PRR: FSCD prototype comments and updates

First stage clock distribution

Power up sequencing

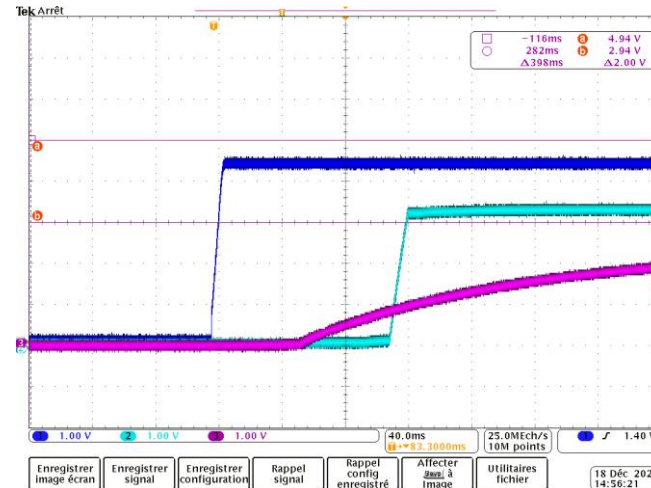
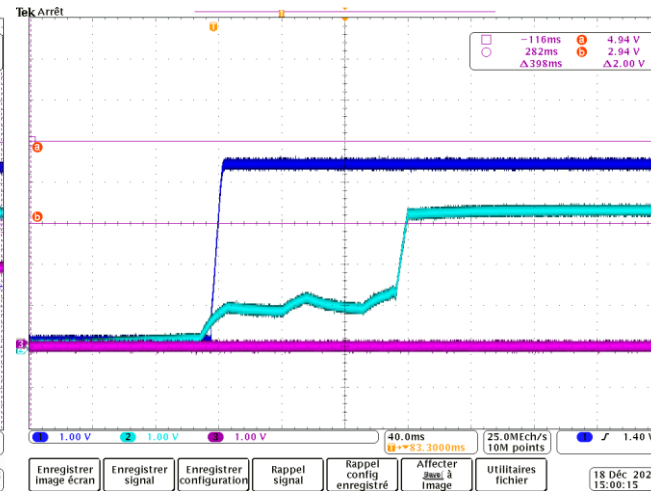
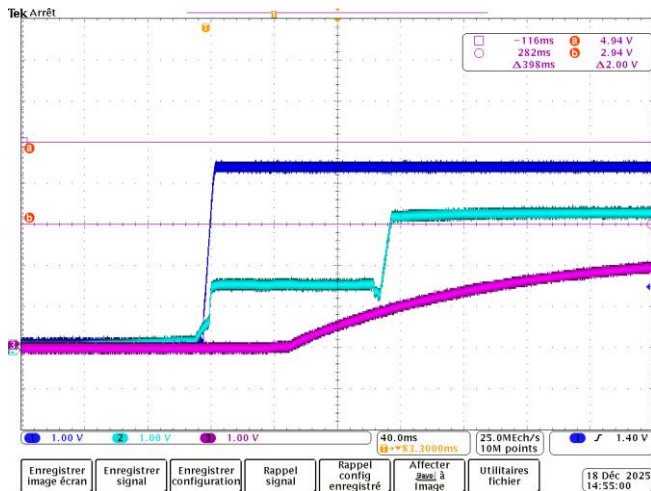
2 different power issues during boot sequence:

- Power delay on Vpow
- Screen reverse powering FPGA bank

First issue can be solved by updating the micro controller software.

The second issue was not mentioned by Denis. It seems to come from a reverse powering of an FPGA bank.

Screen is powered before the FGPA, pulls up its communication line to the FPGA for a short duration. This line may be powering the FPGA bank hence seeing tension on 3V3_io line.

Maybe the screen software can be changed, we need to look into it.

Power sequencing

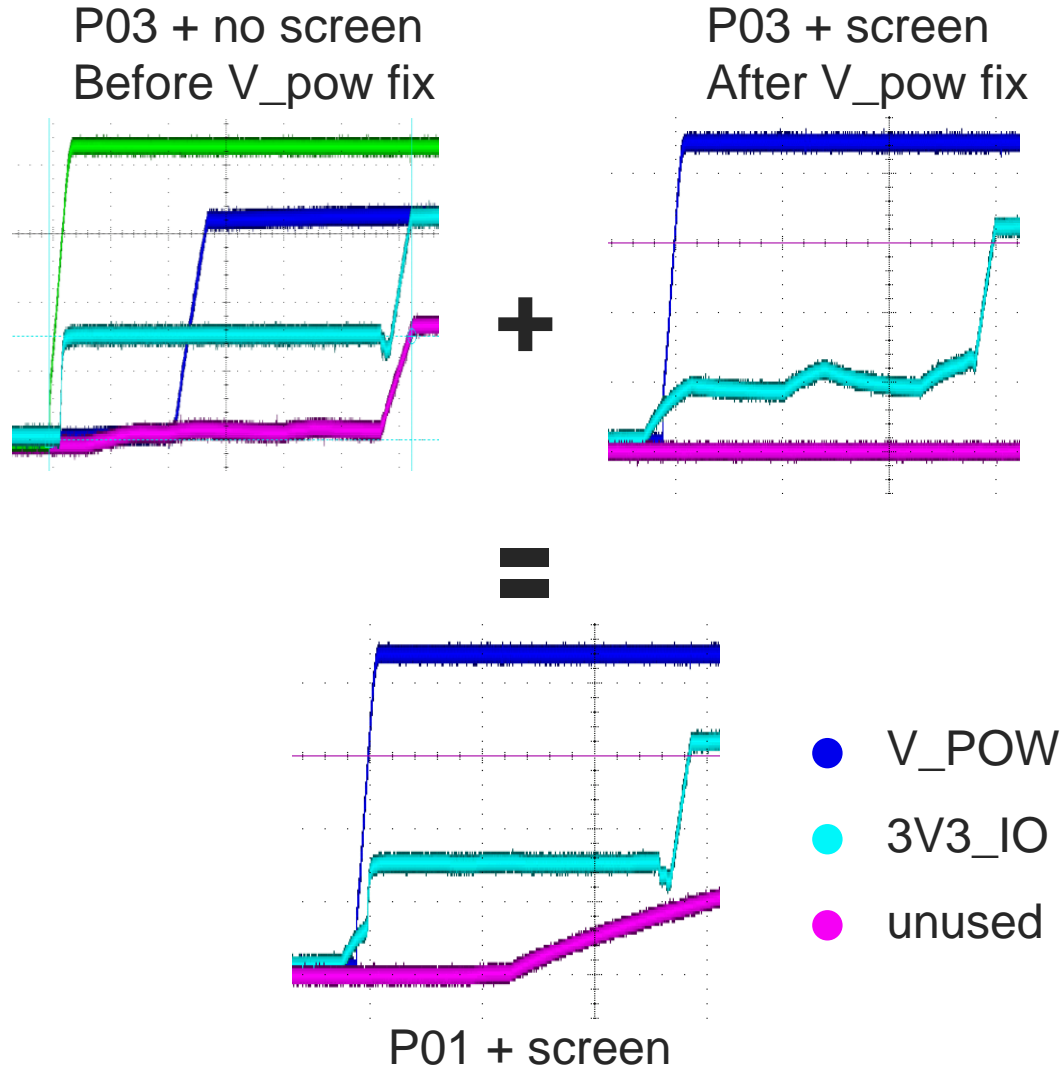
“Delay is introduced in the micro-controller software so that V_POW is started well after 24V_FS is established.” –Denis

Redundant power supply

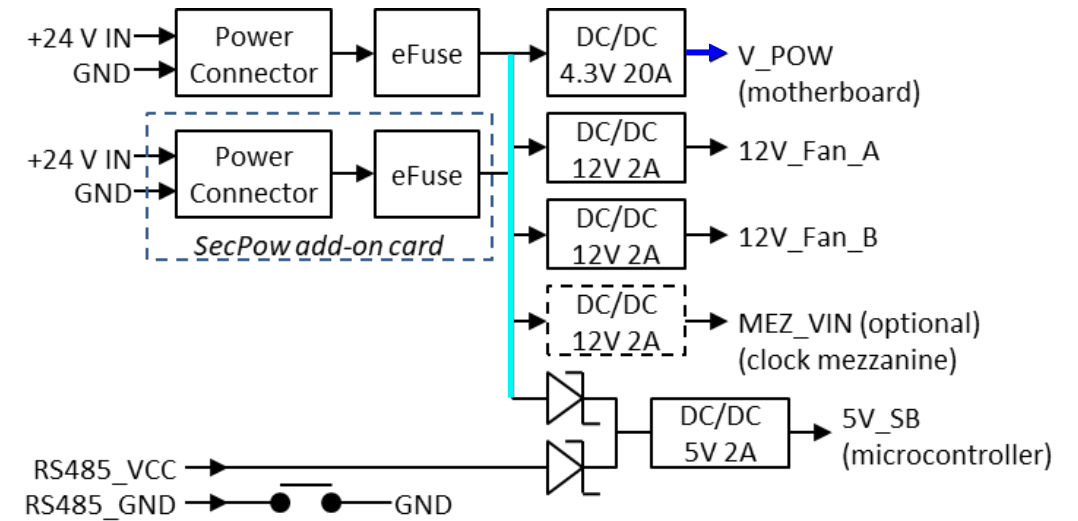
A transistor is used next to the eFuse to detect reverse voltage.

- The used power supply is the one with the highest voltage.

During run time, the main and spare power supply will be set at 24 V and 23 V respectively.

No power will be drawn from the spare power supply until the main is deactivated.

Automatic and seamless switch between power supplies.

Retesting sinusoidal input on FSCD

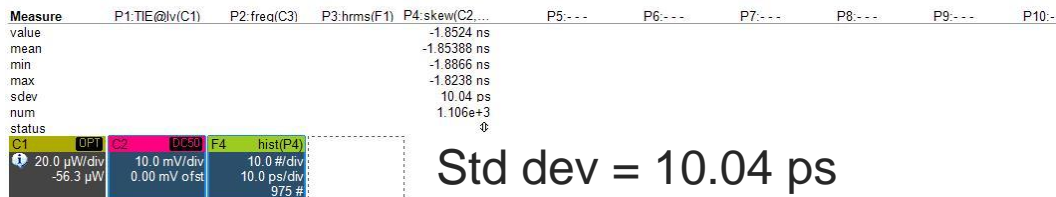
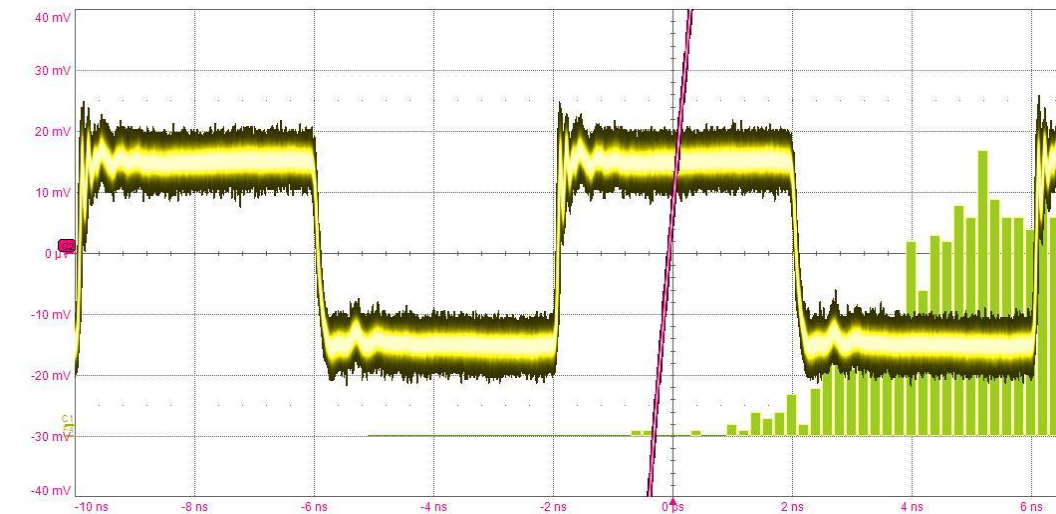
Even with a large vertical scale, the oscilloscope cannot perform a precise measurement.

Upon 10 reset, FSCD always find the same offset compared to the 5MHz clock though it is using the sinusoidal input. If it had issue I would expect a far larger phase variation than the 17 ps peak to peak here.
 ➤ Therefore I think the scope struggles to find the rising edge of a slow signal (sinusoidal).

Current clock distribution topology

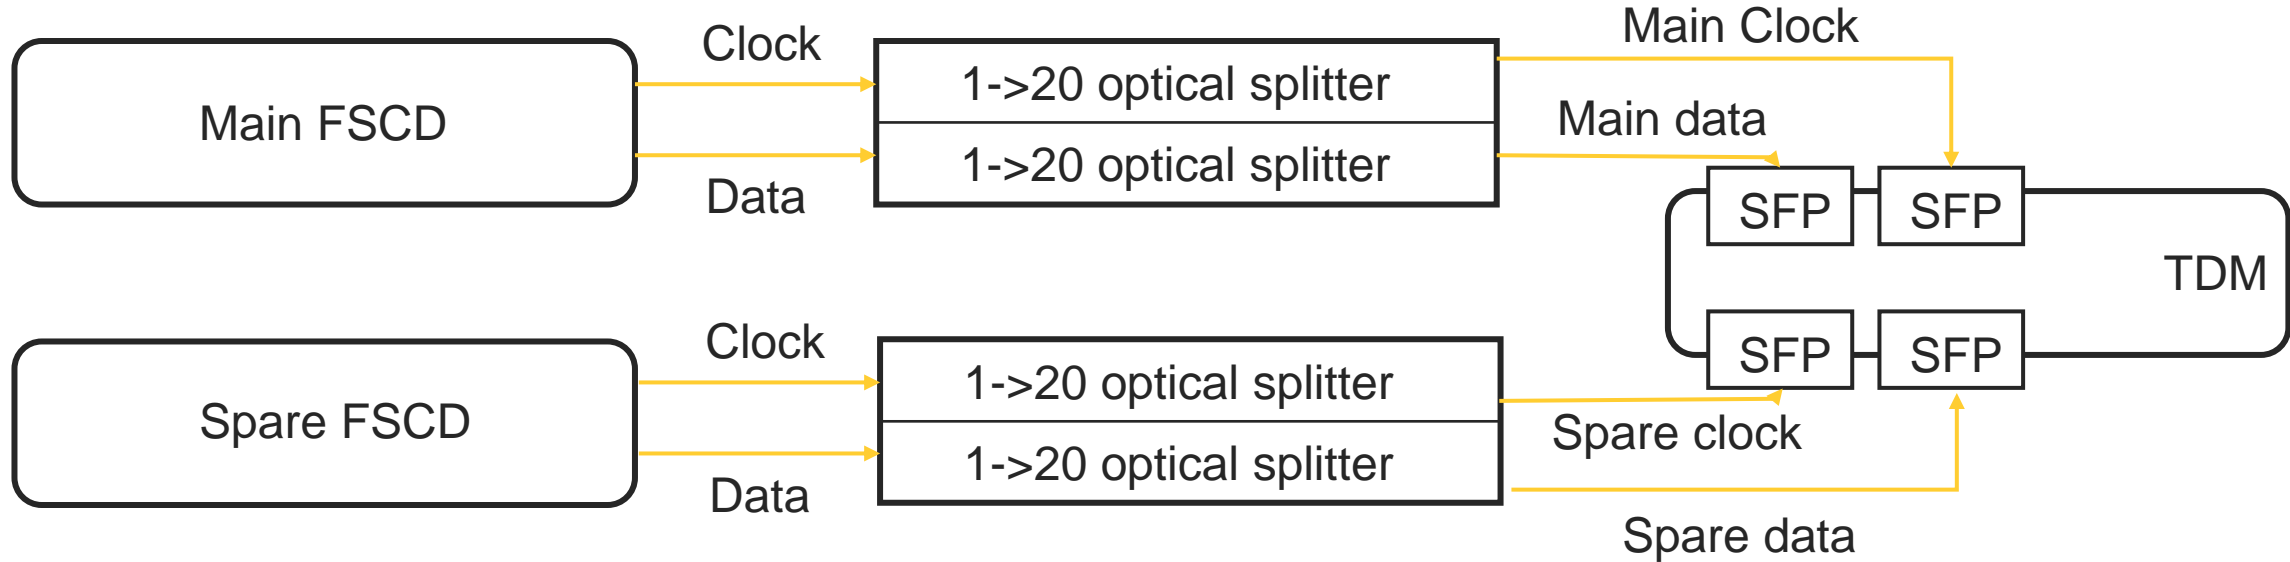
Unknown procedure for switching FSCD in case of failure.

But requires actions from TDM board, switching PLL input from one SFP to another.

➤ We can slightly modify this architecture using 2x32 optical splitters.

Proposed clock distribution topology

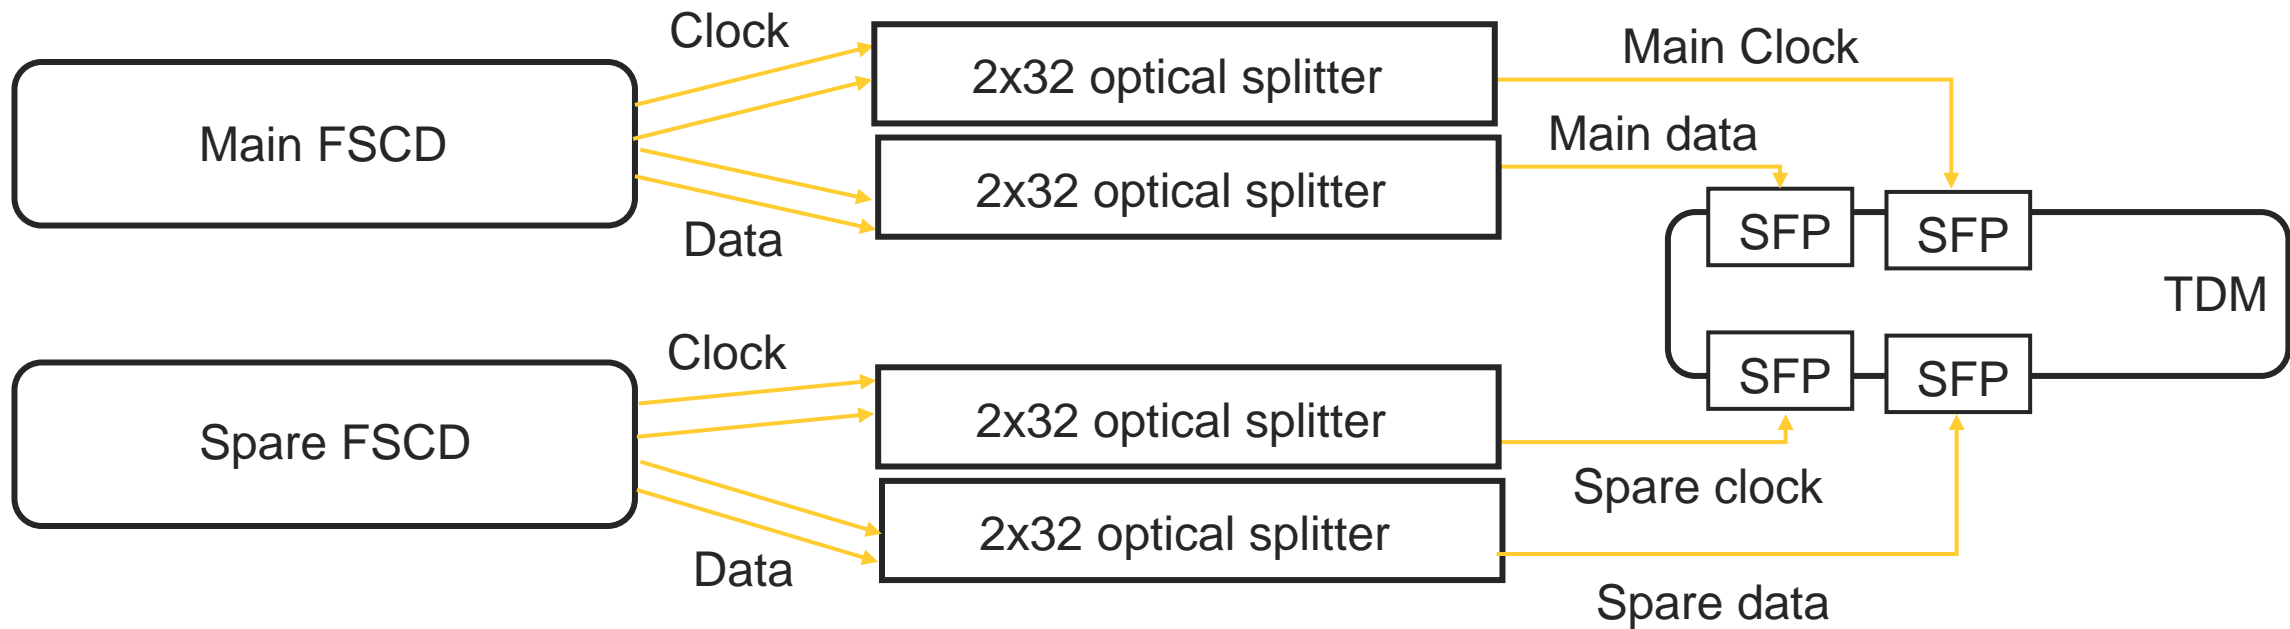
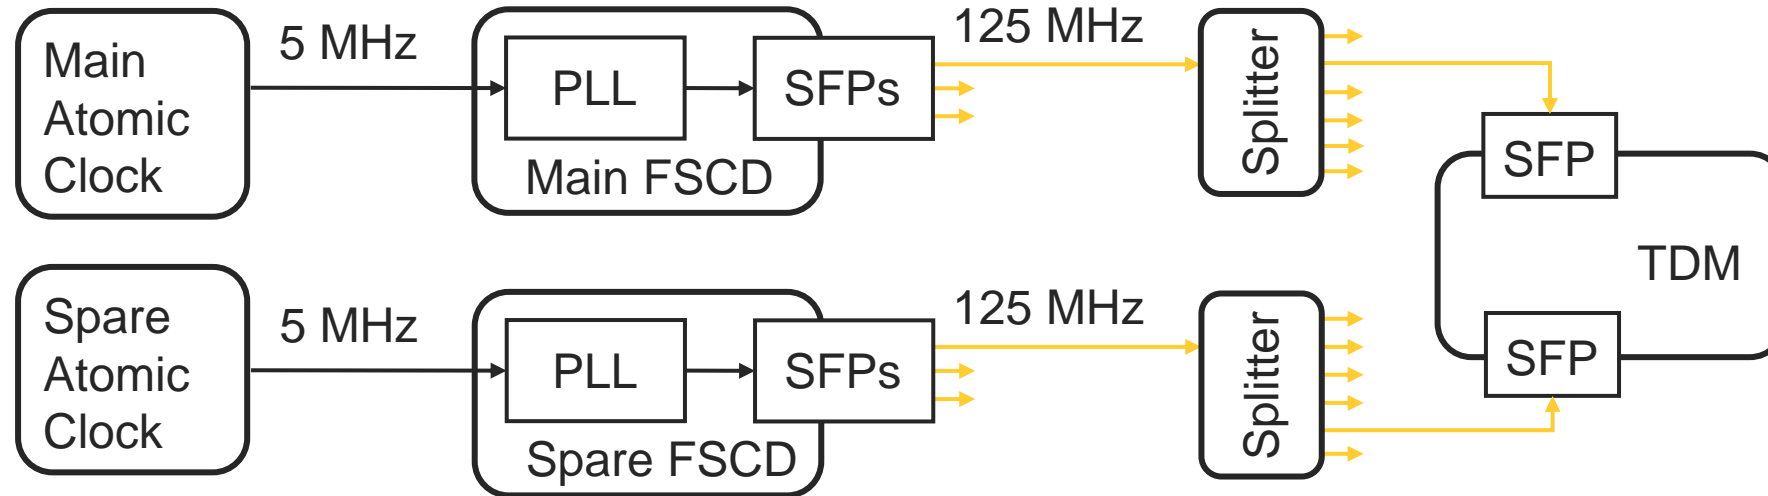
➤ Using the second input of the splitter for a backup SFP.

Only 1 SFP emitting light per optical splitter, the other laser should not age.

Allow for redundancy before switching to secondary FSCD board.

There may be a 150 ps phase shift when switching splitter input. (~100ps SFP + 30 ps splitter input)

Uses 4 units of space in the side hut rack.
